OWNER'S NAME: WILLIAMSON COUNTY LANDFILL
PROJECT NAME: PROPOSED LEACHATE STORAGE TANKS
BID DATE: MAY 9, 2018

ADDENDUM NO. 1
APRIL 19, 2018

WILLIAMSON COUNTY LANDFILL
 LEACHATE STORAGE TANKS
 LEIPERS FORK
 WILLIAMSON COUNTY, TENNESSEE
 NEW FRP STORAGE TANKS
 NOZZLE SCHEDULE

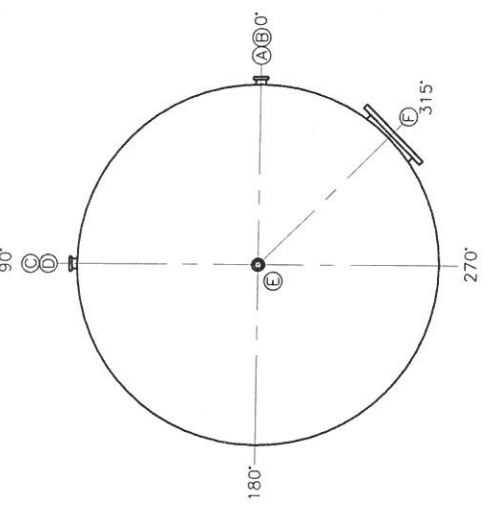
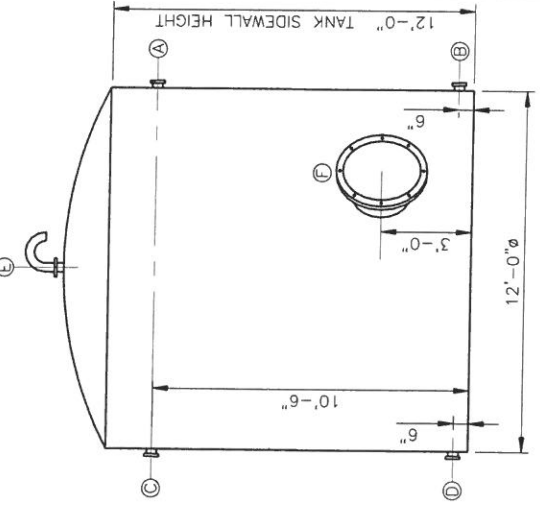
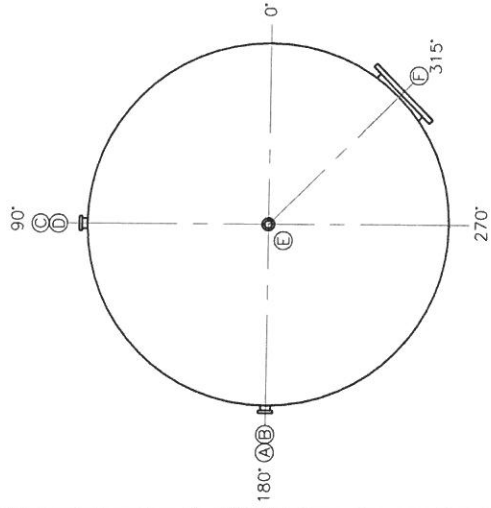
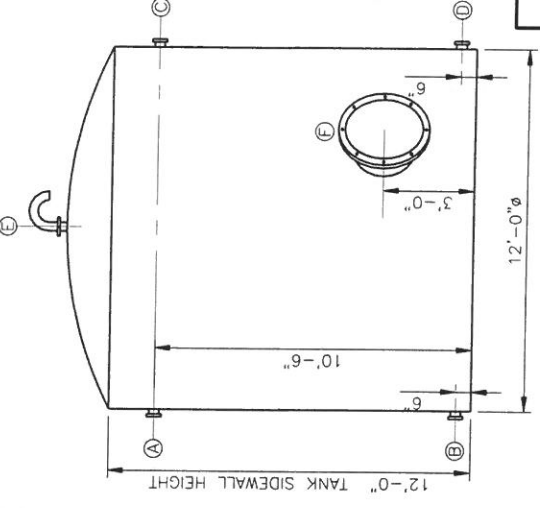
Engineer's drawing of the tank nozzles/fittings required for the tanks is attached with this Addendum No. 1 submittal. In addition, there will be no heat tracing required for the tanks. The specifications call only for insulation.

- F. Section 1.5.F has been revised to the following:

F. *Proposed Tank Nozzles/Fittings (Refer to Nozzle Plan/Schedule from Engineer)*

- 1. *Provide two (2) -4" conically (or blade) gusseted flanged openings per tank (6 inches from the tank bottom to centerline of opening), one for the lower pipe for level equalization and one blind-flanged stub-out for future, lower load-out piping connection.***

2. *Provide two (2) – 4” conically (or blade) gusseted flanges per tank (10’-6” up from bottom of tank to centerline of opening), one that is blind flanged for future use for transducer (or other) equipment access and one for the upper overflow (both located near top of tanks).*
3. *Provide 1 –FRP gooseneck vent per tank with insect screen.*
4. *Provide 1 – 24” side flanged manway per tank with Cover, EPDM gasket and 304 SS stainless steel fasteners.*
